Access Compliance Report Public Rights-of-Way (Curb Ramps)

Main Street: COW_CAMP_RD		Cross Street: ANTONIO_PKWY		Location:	SE
ADA ID: RPRK211123130034	Ramp Type: Type 1 - Perpendicular	Initial Pass/Fail: Fail	Overall Compliance: No	Severity Score:	15
Codes/Mitigation Info/Possible Solution			Field Measurements/Component Compliance

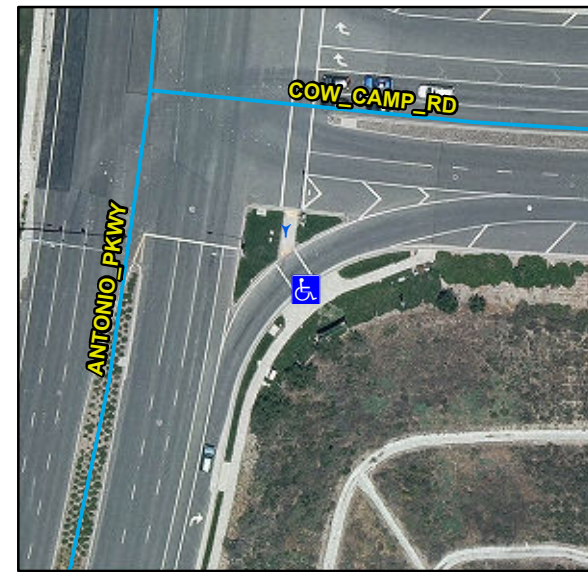
R304.2.2, R304.5.3, STD 1115

Remove & Replace Entire Ramp.
